RAMSEY WATER TREATMENT PLANT
 CITY OF RAMSEY
 RAMSEY, MN
 RESERVOIR ROOF PLAN AND ELEVATIONS

RAMSEY WATER TREATMENT PLANT
 CITY OF RAMSEY
 RAMSEY, MINNESOTA

RAMSEY WATER TREATMENT PLANT
 CITY OF RAMSEY
 RAMSEY, MINNESOTA
 SITE PLAN

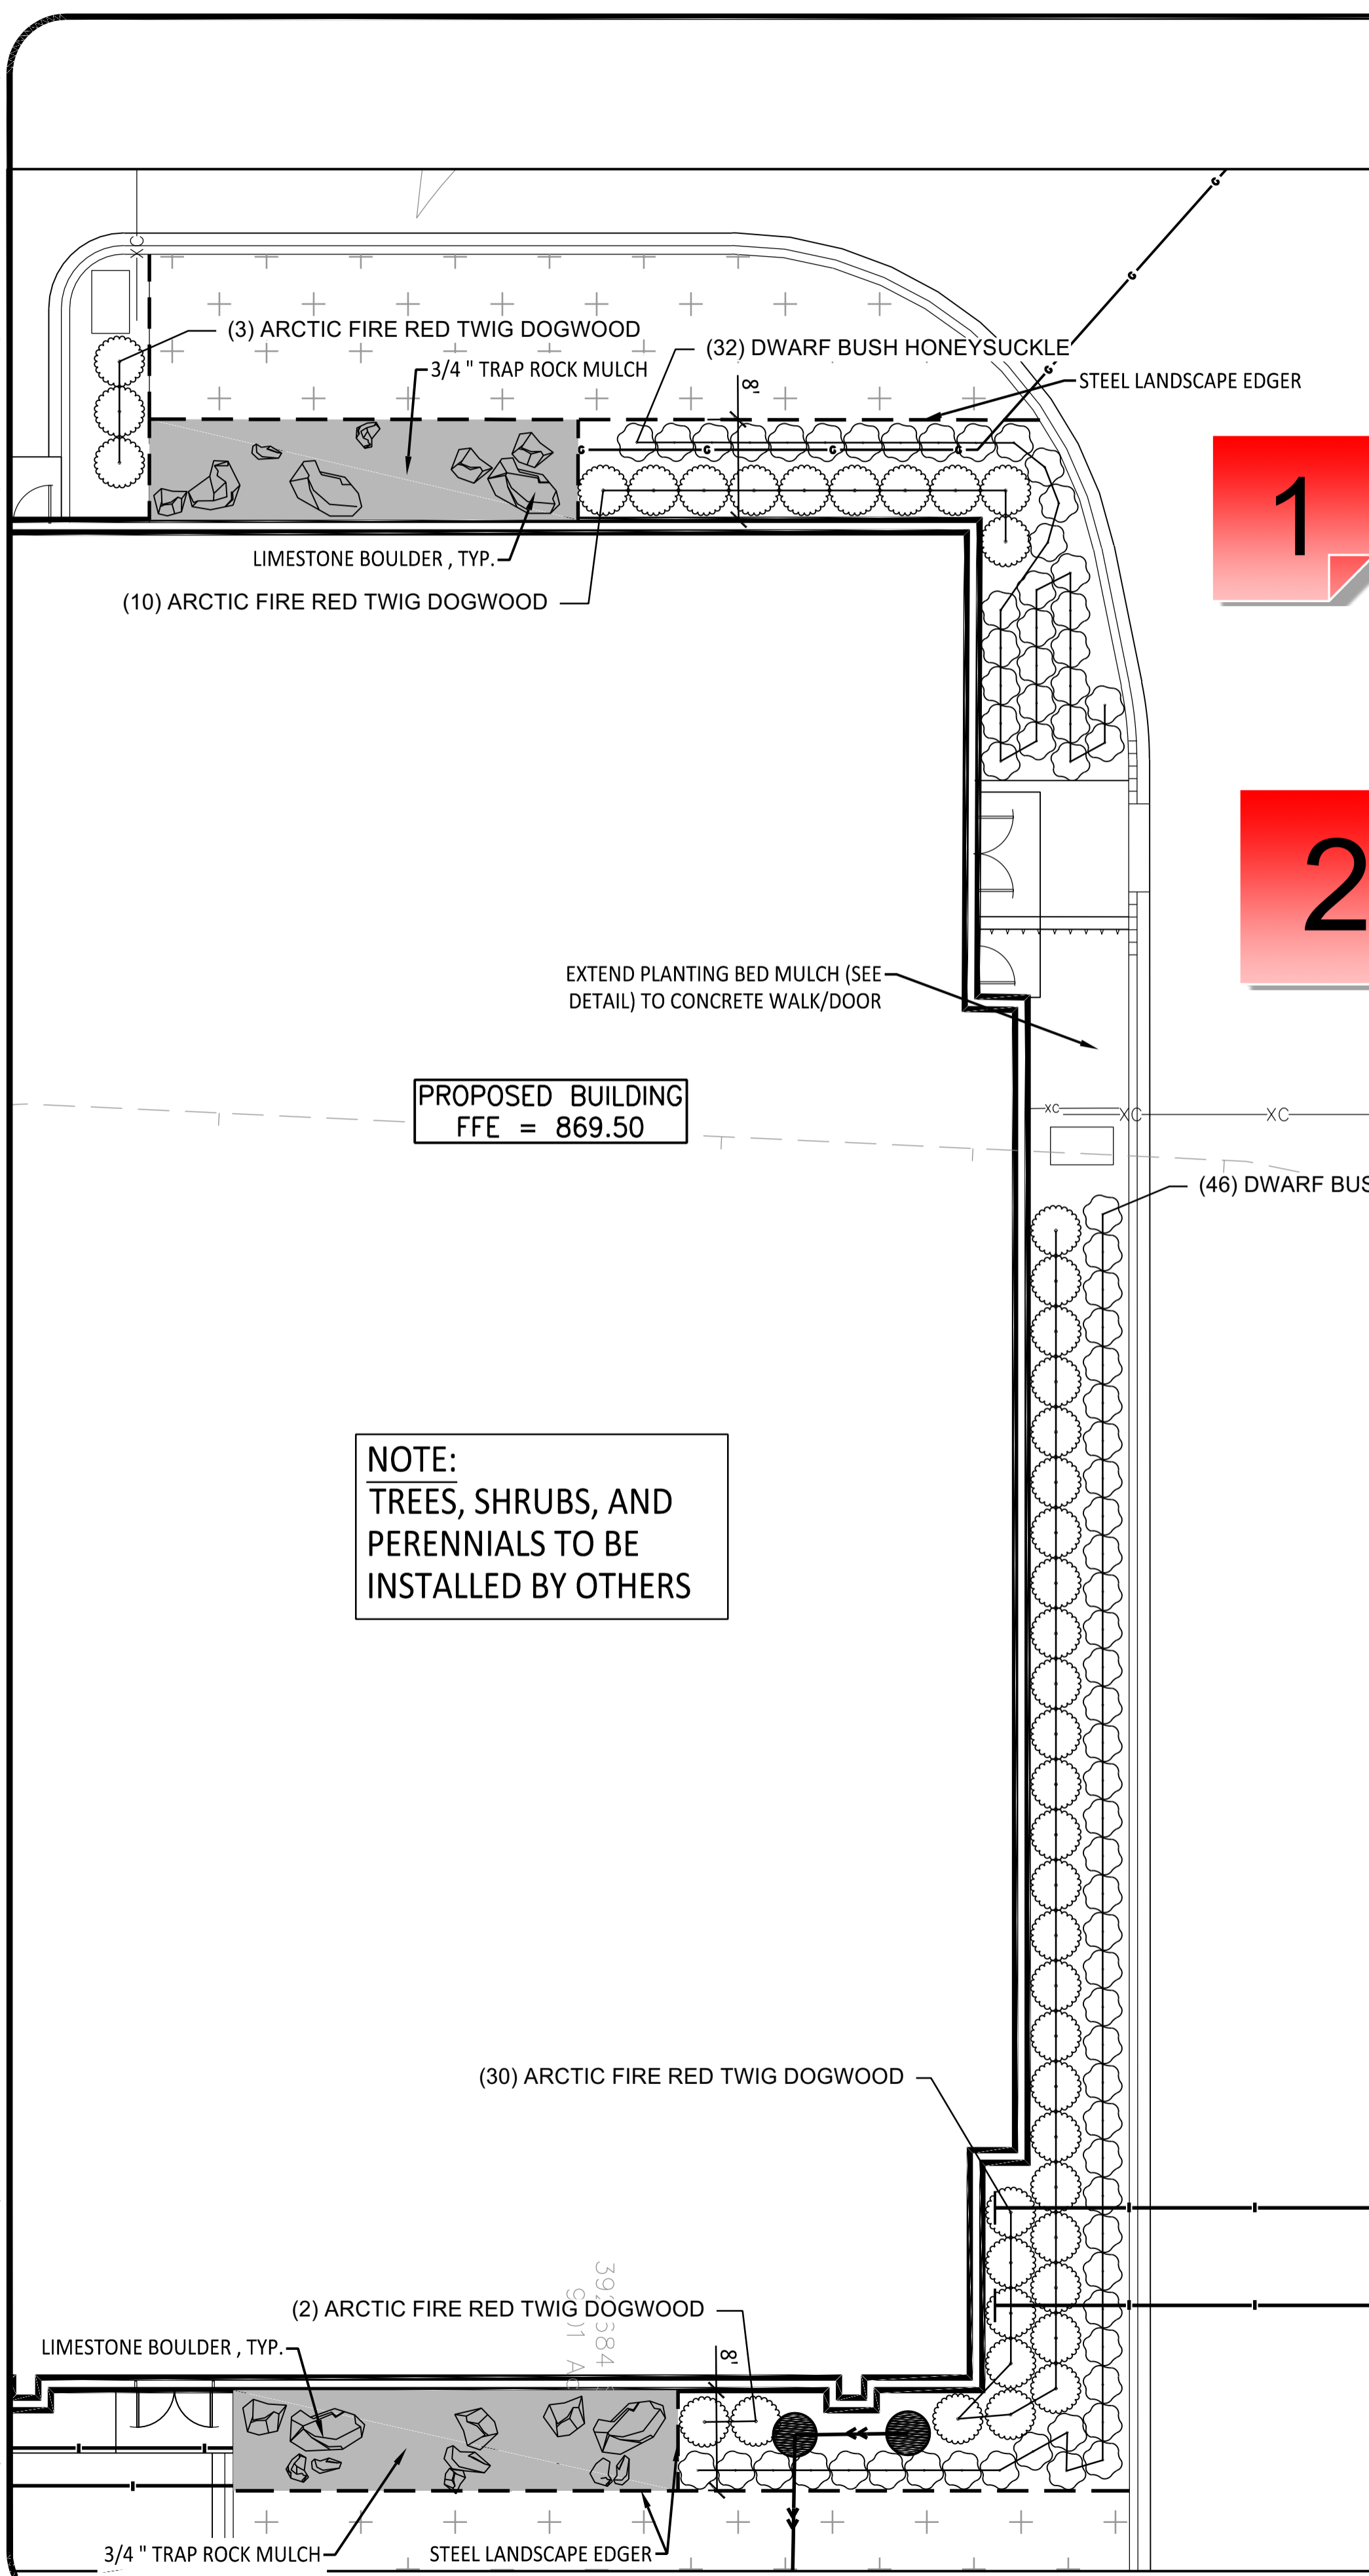
Provide information on these two water lines and connection point

Add gate valve at connection point so that contractor does not have to test existing line

This structure does not appear to be connected with any outlet

DRAWING
L101

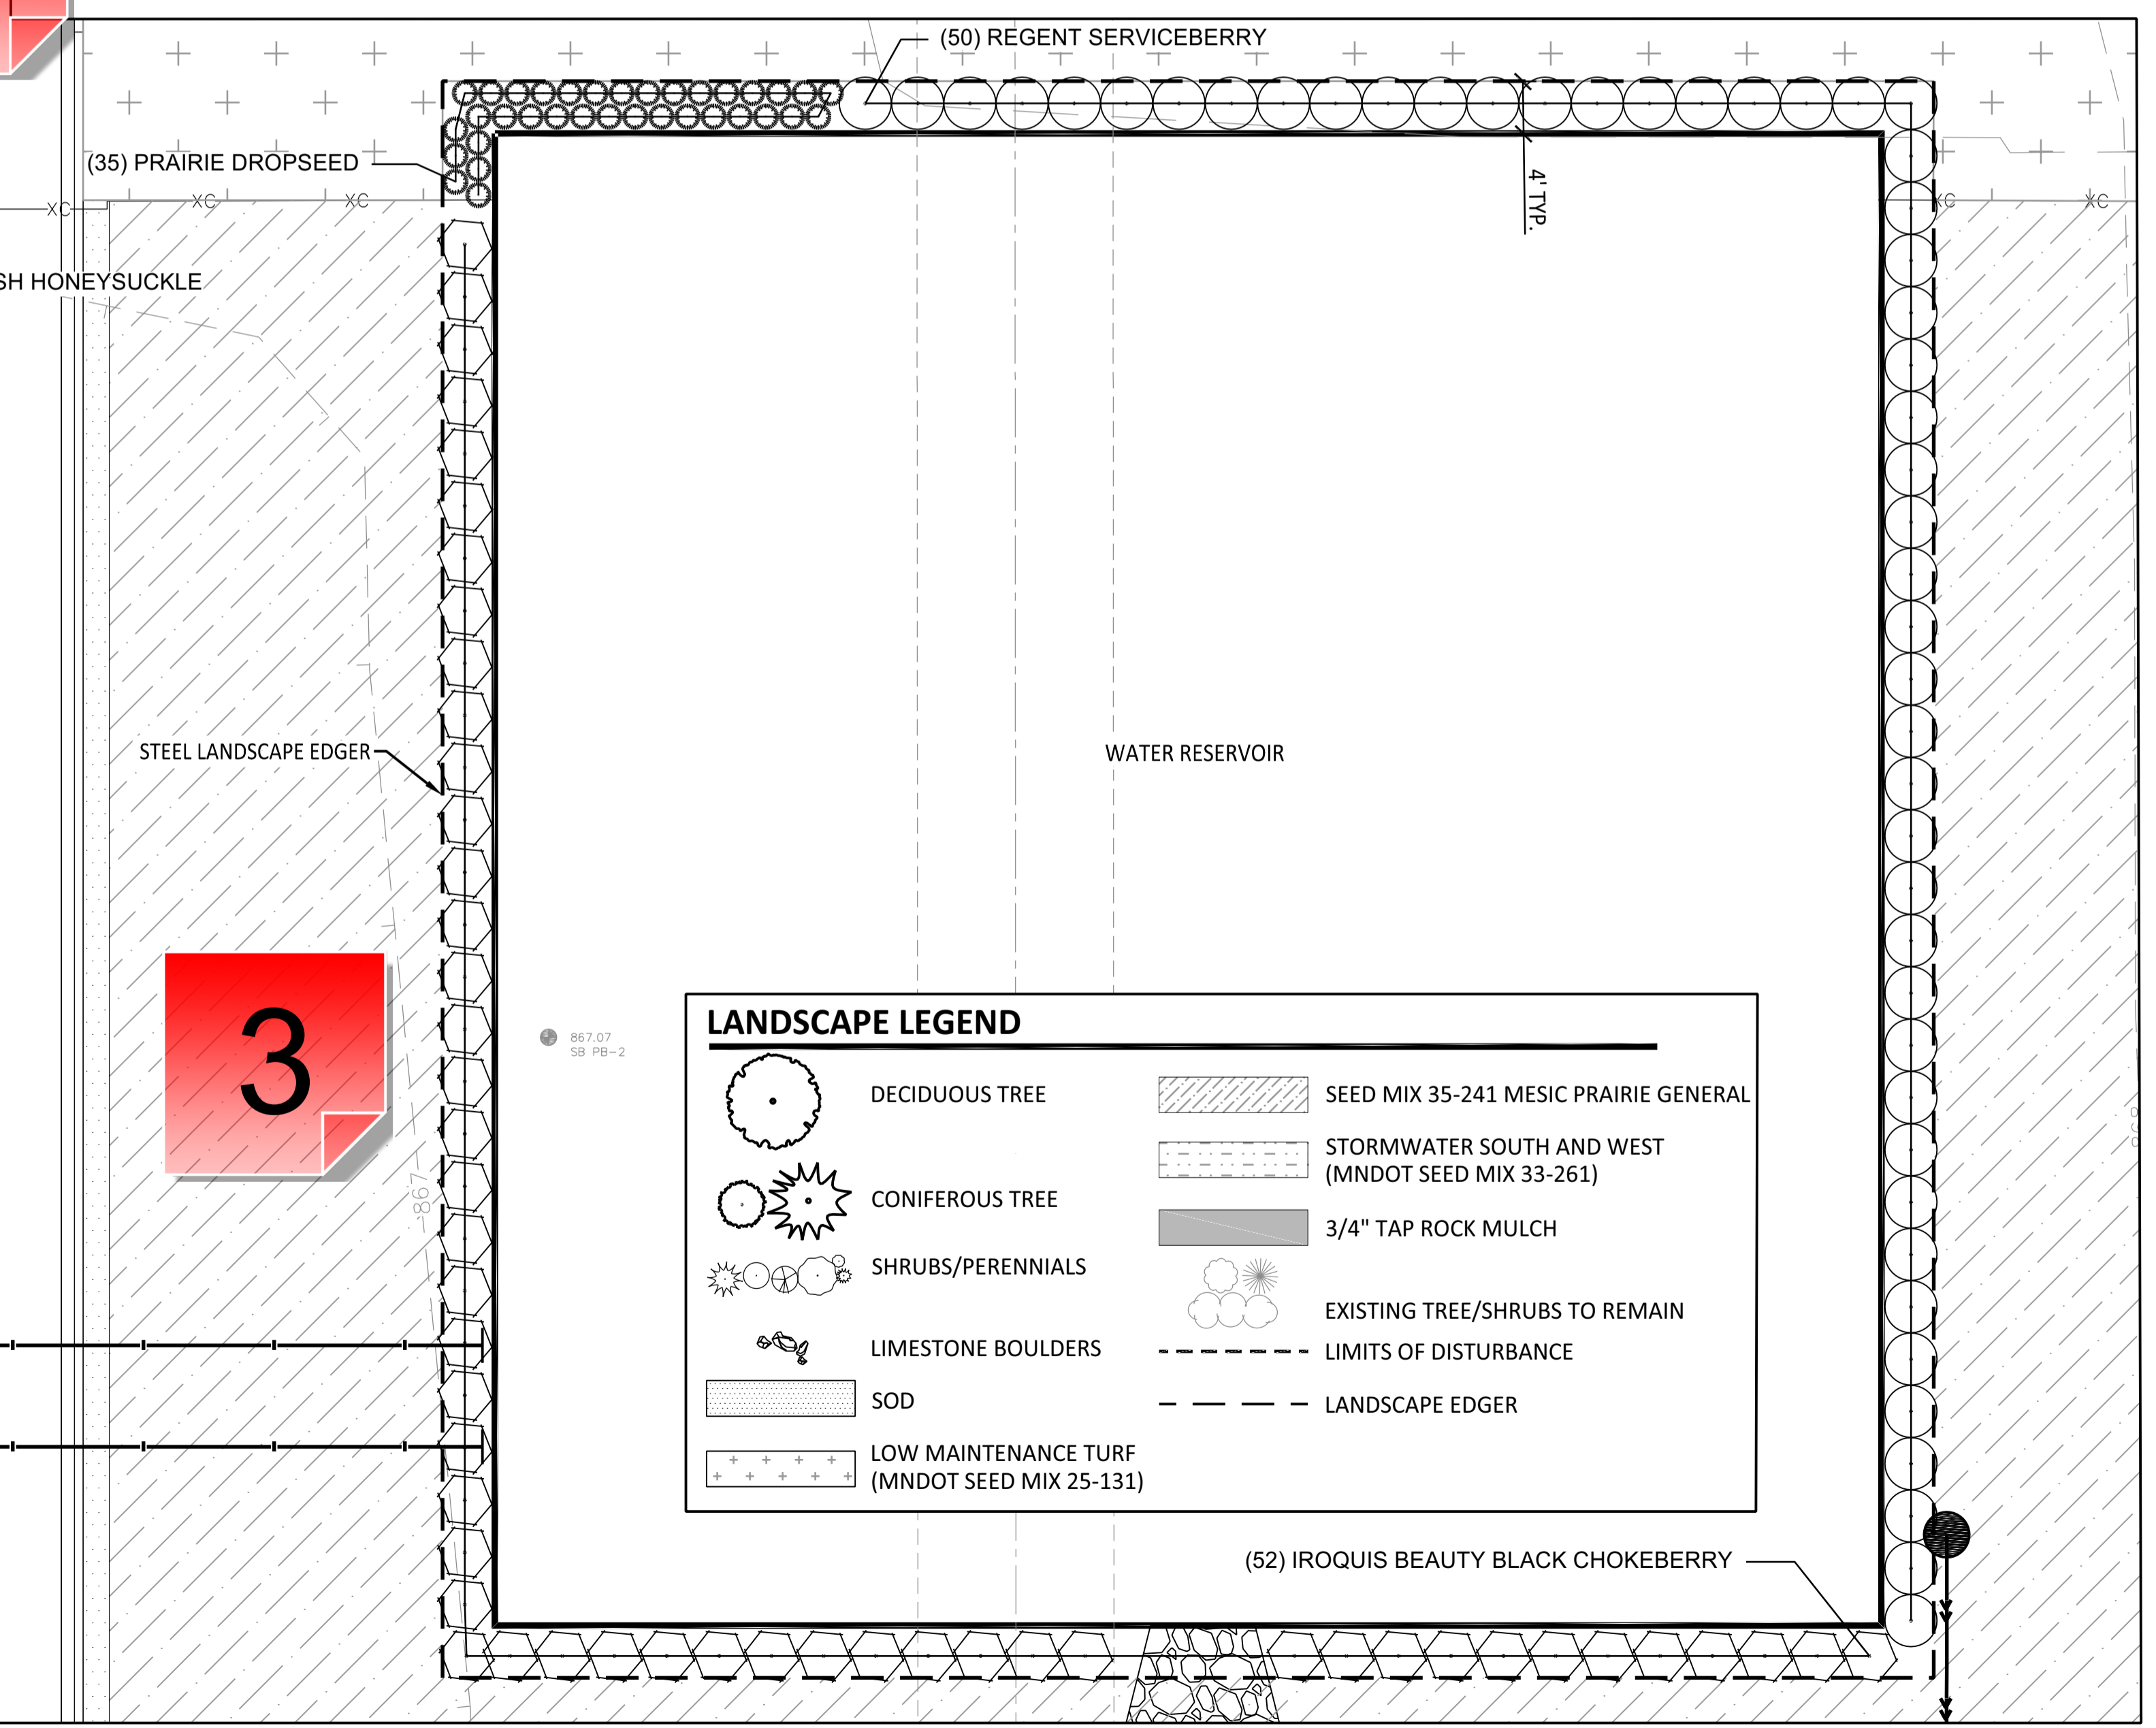
Shrubs shall be at least 24" in height. Update Plant Schedule to speciy size as 24" rather than container size.

The Plant Schedule is missing the coniferous trees. Please update to include the Norway Spruce and White Pines proposed on the plan sheet.

Please provide a detailed 3-5 year management plan for the prairie area. The plan shall describe the prescribed management activities, include a calendar of when these activities shall occur. A competent subcontractor shall be identified to perform the management activities.
